Instrument Panel Supplemental Wiring – Left Switch
Models: 1199 Panigale (all country versions, all models)
Recall Bulletin RCL-14-001

This Recall bulletin supersedes the previous document, TSB-13-002 and TSB-14-003 Instrument Panel Supplemental Wiring, and Tips & Tricks No. 64.

Technical solution implementation:

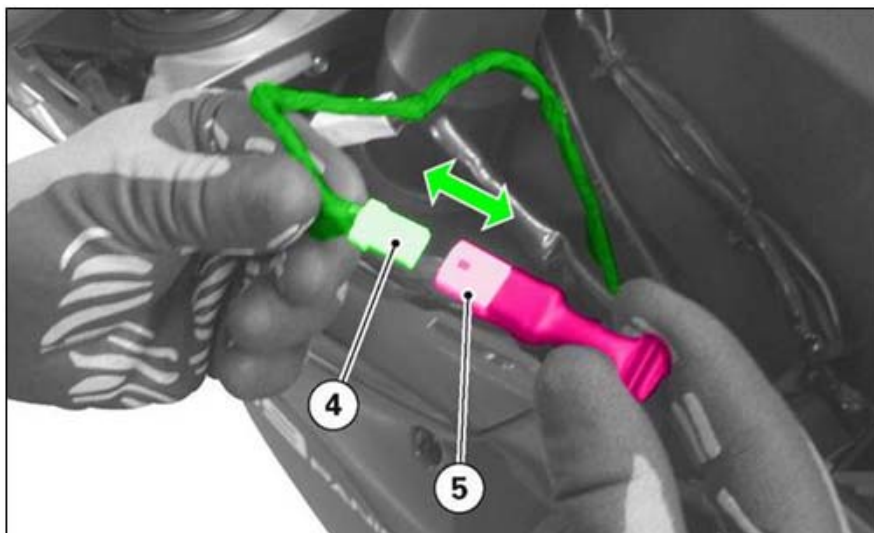
- 1) Remove ignition switch cover and LH conveyor cover (sections 05 and 08 of workshop manual);
- 2) Remove the three retaining ties; the **large tie (1)**, the **small tie (2)**, and the **button tie (3)** L=62 mm.

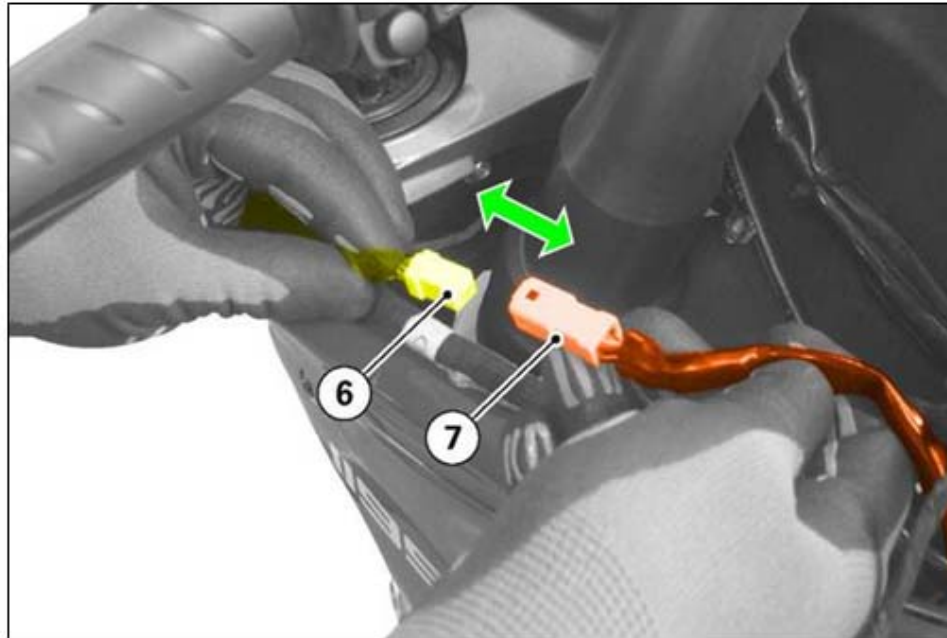
- 3) Disconnect the following wiring:
 - Wiring branch connector for **GPS (4)** and **cap (5)**;

- Left switch wiring **branch connector (6)** and **left switch cable (7)**;

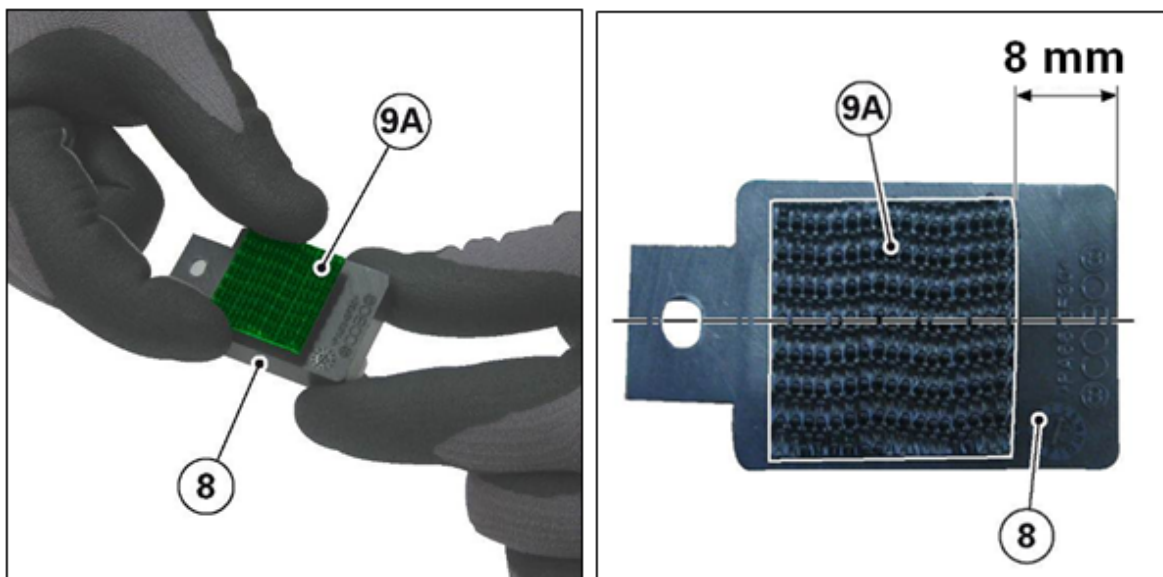
- 4) Apply one side of the **3M DUAL LOCK Velcro (9A)** at the bottom of the additional **wiring module (8)**; thoroughly clean the mating surface with degreaser before applying.

The 3M DUAL LOCK Velcro **(9A)** has to be positioned at the distance shown in the figure below:

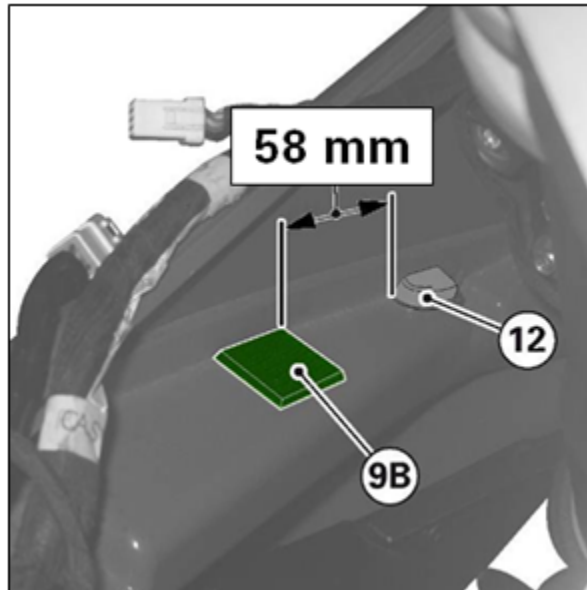
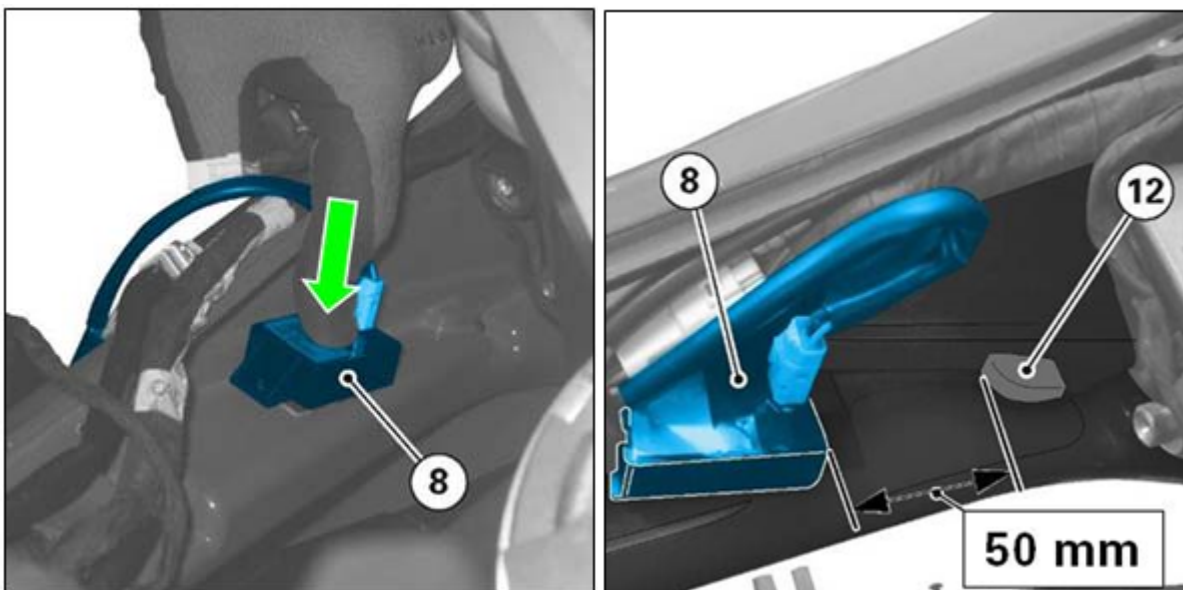
- 5) Apply the remaining side of the **3M DUAL LOCK Velcro (9B)** inside headlight fairing, left-hand inner compartment. Thoroughly clean the mating surface with degreaser before applying.

Velcro (9B) has to be positioned at the distance shown in the figure below:

- 6) Position the module, present on additional wiring harness (8), onto the Velcro (9B), respecting the distance of 50 mm from inner profile (12).

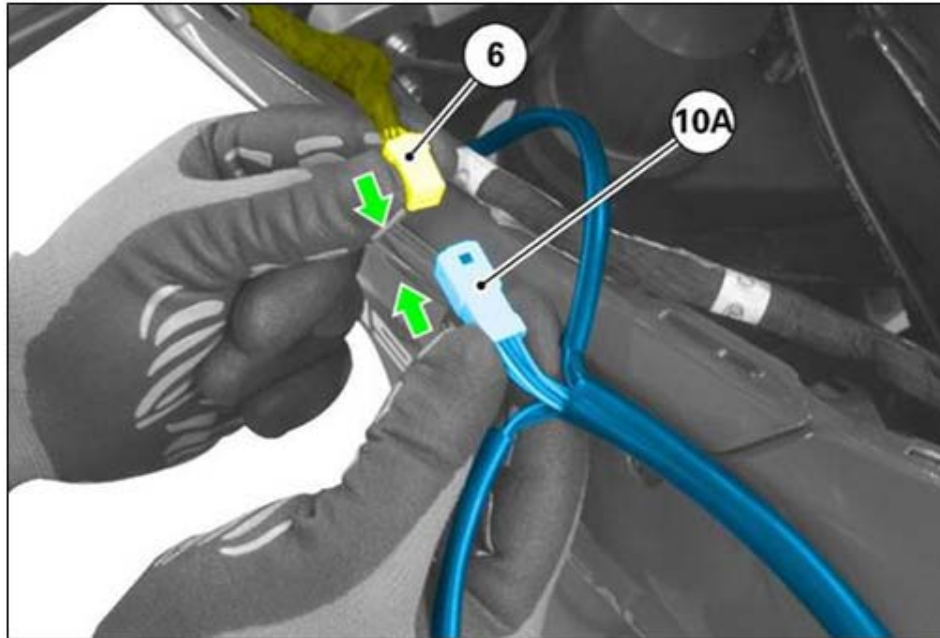
- Left switch wiring branch **(6)** with connector **(10A)** on additional wiring harness;

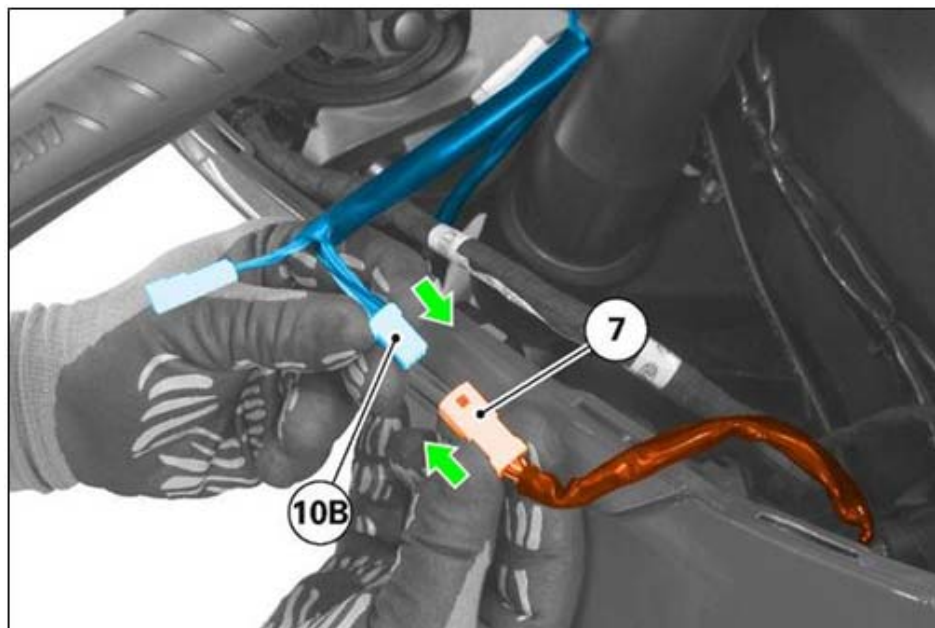
- Left switch cable **(7)** with connector **(10B)** on additional wiring harness;

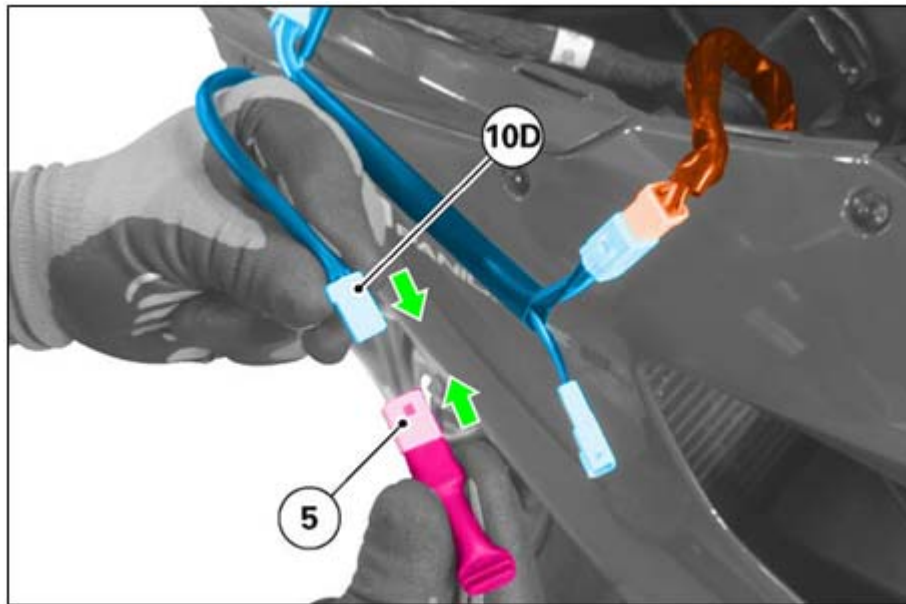
- Cap **(5)** with connector **(10D)** on additional wiring harness;

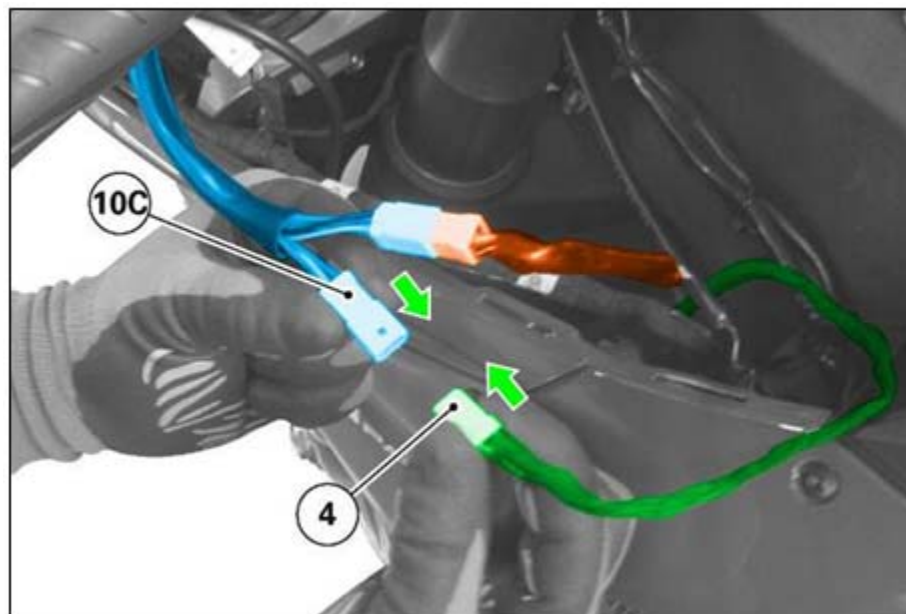
- Wiring branch for GPS **(4)** with connector **(10C)** on additional wiring harness;

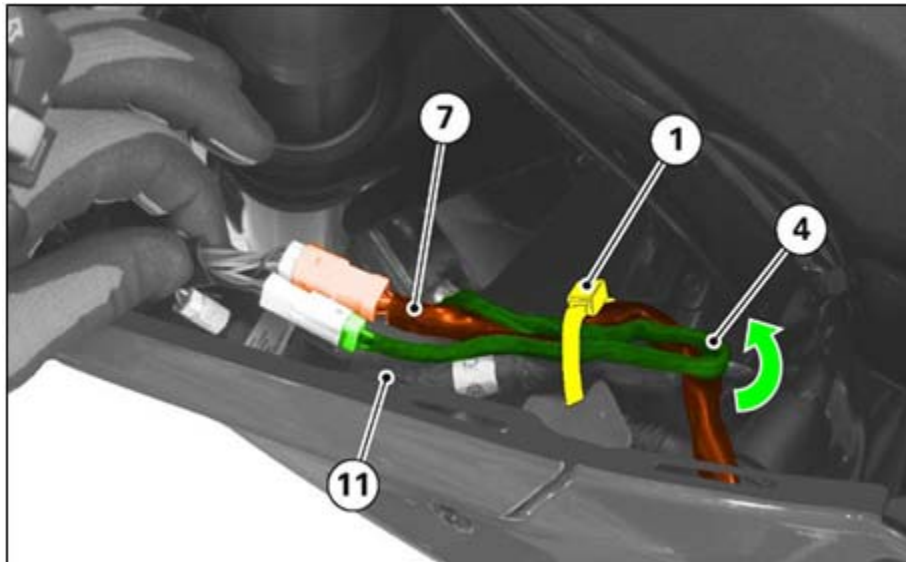
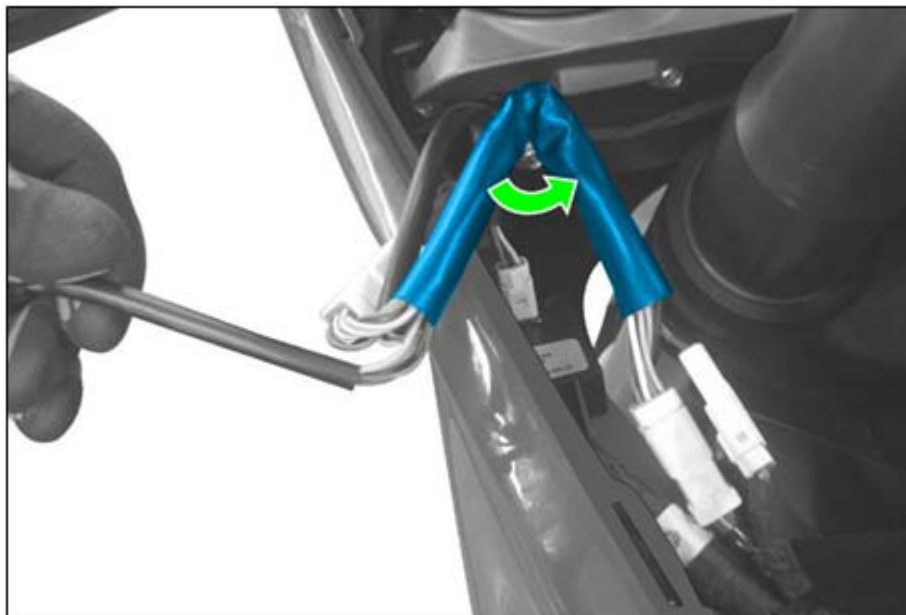
- Insert large tie **(1)** inside left-hand electrical component support; secure left switch cable **(7)**, main wiring front branch **(11)** and wiring branch for GPS **(4)** (after bending the latter as shown in the figure below).

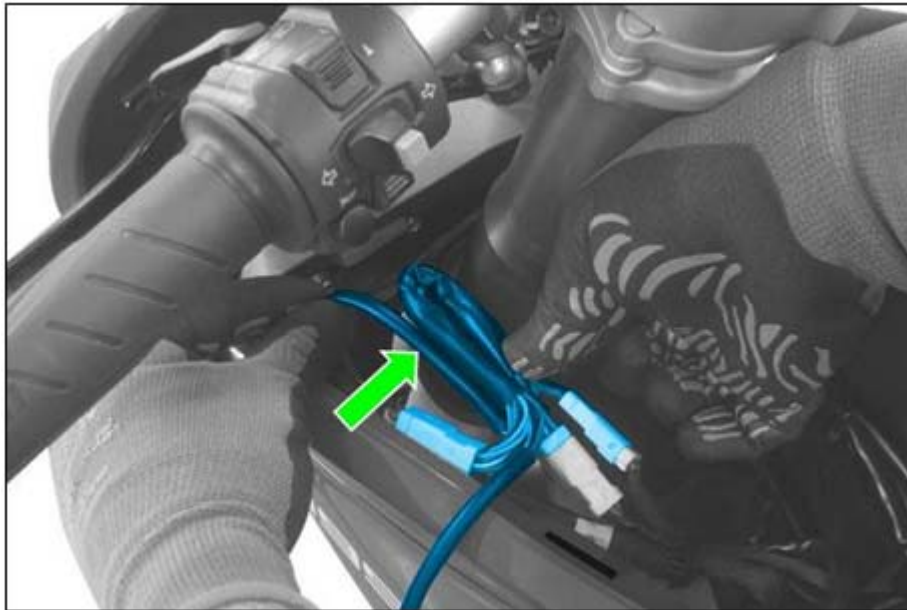
- Bend additional wiring harness central section, as shown in the figure below;

- Join the additional wiring branch for the module, to the previously bent wiring described above, as pictured below;

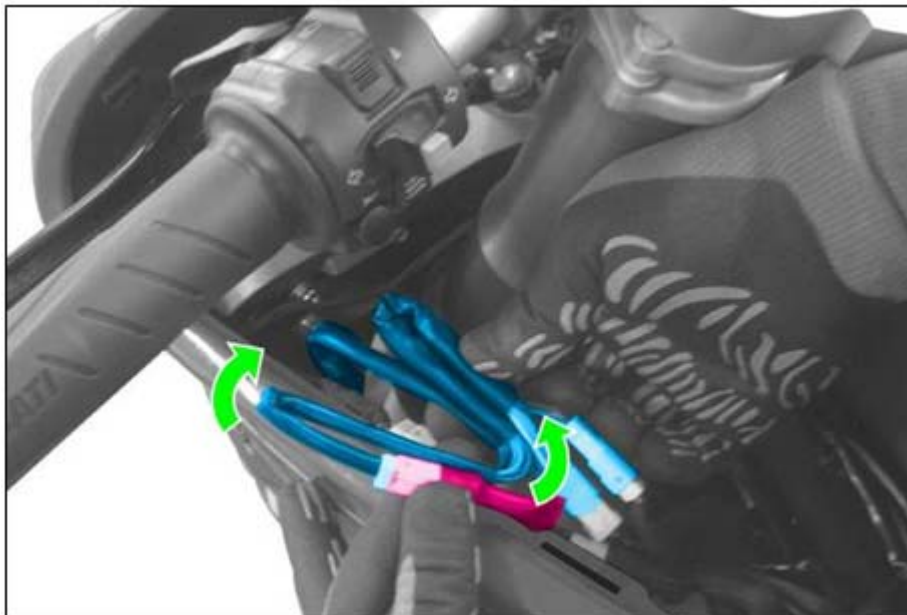
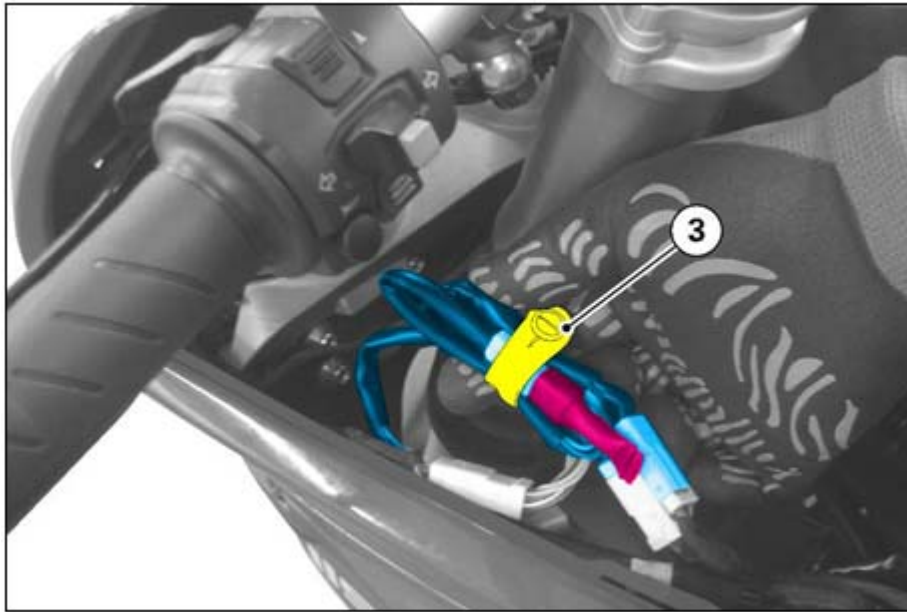
- Finally, bend the additional wiring branch, connected with the cap, as shown in the figure below, and join it to the other cables.

- Secure the joined cables with button tie **(3)**, L=62 mm, you had previously removed;

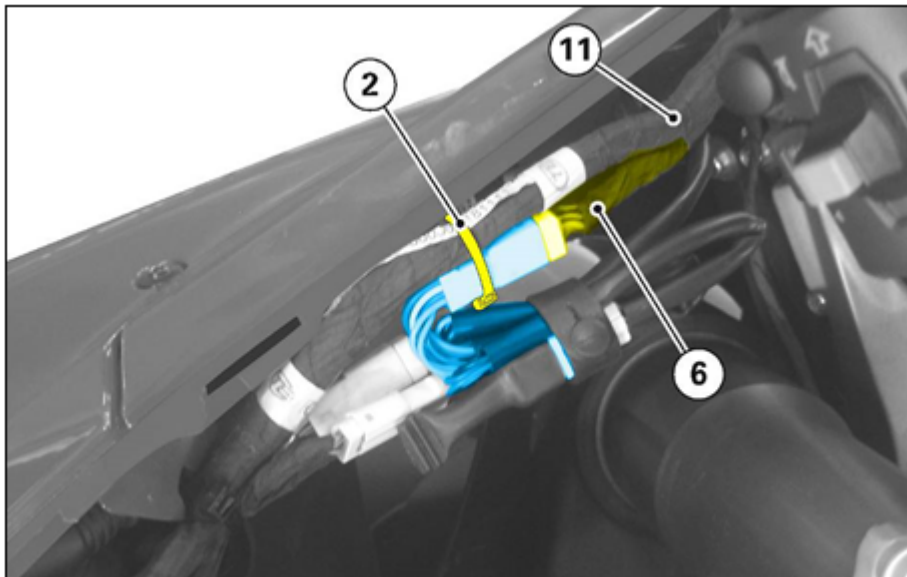
- 9) Loop the small tie **(2)** so as to lock in place the left switch main wiring **(6)** to the additional wiring, and main wiring front branch **(11)**.
